Access Compliance Report Public Rights-of-Way (Curb Ramps)

Main Street: RANCHWOOD_RD Cross Street: EVENINGSIDE_DR Location: NW

ADA ID: RPAT211013145452 Ramp Type: Type 3 - Combination 1 Initial Pass/Fail: Fail Overall Compliance: No Severity Score: 2

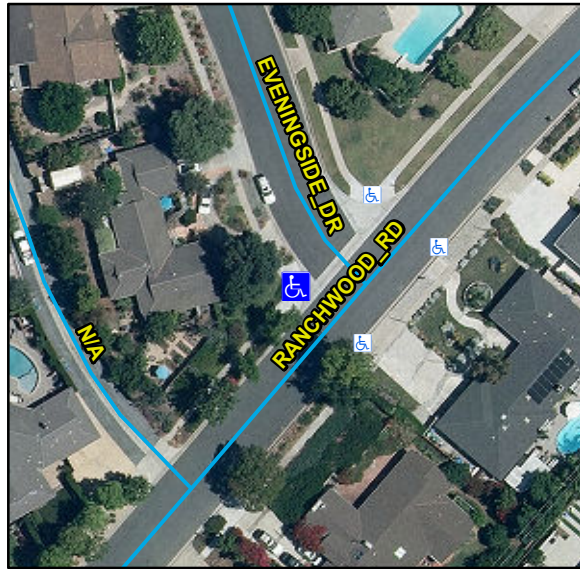
Compliance	Description	Data	Compliance	Description	Data
N/A	Ramp Length LT (in)	69	N/A	Ramp Length RT (in)	99
Yes	Ramp Width LT (in)	57	Yes	Ramp Width RT (in)	50
Yes	Ramp Run Slope LT (%)	4.8	Yes	Ramp Run Slope RT (%)	6.6
Yes	Ramp Cross Slope LT (%)	0.8	No	Ramp Cross Slope RT (%)	2.8
N/A	Ramp Length (in)	41	N/A	Flare Type LT	
Yes	Ramp Width (in)	48			N/A
Yes	Ramp Run Slope (%)	7.3	N/A	Flare Slope LT (%)	N/A
Yes	Ramp Cross Slope (%)	1.5	N/A	Flare Traversable LT	N/A
N/A	Landing Present	N/A	N/A	Flare Type RT	
N/A	Landing Length (in)	N/A			N/A
N/A	Landing Width (in)	N/A	N/A	Flare Slope RT (%)	N/A
N/A	Landing Run Slope (%)	N/A	N/A	Flare Traversable RT	N/A
N/A	Landing Cross Slope (%)	N/A	N/A	DWS Provided	N/A
N/A	Landing Movement Obstructed?	N/A	N/A	DWS Contrast	N/A
	Landing Movement Type	N/A	N/A	DWS Length (in)	N/A
N/A	Landing Shared	N/A	N/A	DWS Full Width	N/A
N/A	Clear Space	Yes		DWS Offset Type	N/A
N/A	Clear Space To Crosswalk (in)	N/A	N/A	DWS Offset Left (in)	N/A

Remove & Replace Curb Ramp With Two New Directional Ramps or Equivalent.

R304.2.2, R304.5.3, STD 1115
